Access Compliance Report Public Rights-of-Way (Curb Ramps)

Main Street: S_OAKWOOD_ST Cross Street: FAIRHAVEN_AVE Location: NE

ADA ID: RPRK211007112735 Ramp Type: Type 1 - Perpendicular Diagonal Initial Pass/Fail: Pass Overall Compliance: No Severity Score: 15

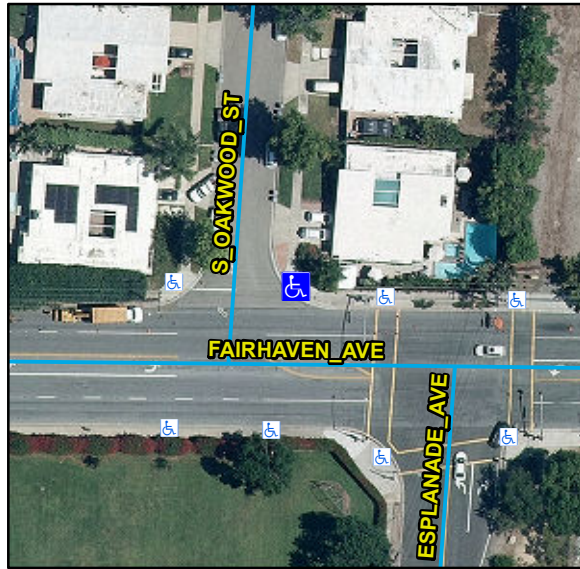
Compliance	Description	Data	Compliance	Description	Data
N/A	Ramp Length (in)	100	N/A	Flare Type LT	
Yes	Ramp Width (in)	48			Sloped
Yes	Ramp Run Slope (%)	7.4	Yes	Flare Slope LT (%)	2.1
Yes	Ramp Cross Slope (%)	0.8	N/A	Flare Traversable LT	Yes
N/A	Landing Present	No	N/A	Flare Type RT	
N/A	Landing Length (in)	N/A			Sloped
No	Landing Width (in)	N/A	Yes	Flare Slope RT (%)	5.5
No	Landing Run Slope (%)	N/A	N/A	Flare Traversable RT	Yes
No	Landing Cross Slope (%)	N/A	Yes	DWS Provided	Yes
N/A	Landing Movement Obstructed?	Yes	Yes	DWS Contrast	Yes
	Landing Movement Type	Curb	Yes	DWS Length (in)	36
N/A	Landing Shared	N/A	Yes	DWS Full Width	Yes
N/A	Clear Space	Yes	Yes	DWS Offset Left (in)	0
N/A	Clear Space To Crosswalk (in)	48	Yes	DWS Offset Right (in)	N/A
N/A	Marked Crosswalk 1	No	N/A	Marked Crosswalk 2	No
	Crossing 1 Direction	W		Crossing 2 Direction	S
	Marked Crosswalk 1 Width (in)	N/A		Marked Crosswalk 2 Width (in)	N/A

N/A	Ramp Inside Crosswalk 1	N/A	Yes	Ramp Inside Crosswalk 2	N/A
	Crossing 1 Slope (%)	4.4		Crossing 2 Slope (%)	2.3
	Crossing 1 Cross Slope (%)	0.2		Crossing 2 Cross Slope (%)	1.1
Yes	Gutter Ponding	No	No	Curb Slope	10.1
Yes	Gutter Lip Height (in)	0		Road Run Slope (%)	1.1
No	Gutter Run Slope (%)	10		Road Cross Slope (%)	9.3
Yes	Gutter Cross Slope (%)	1			
Yes	Overall Surface Condition: Acceptable		Yes	Perp Joint Present	Yes
	Cross Gutter Present?	No		Spandrel Present?	No
	Replace Cross Gutter?	N/A		Replace Spandrel?	N/A

Remove & Replace Curb Ramp With Two New Directional Ramps or Equivalent. Remove & Replace Gutter.
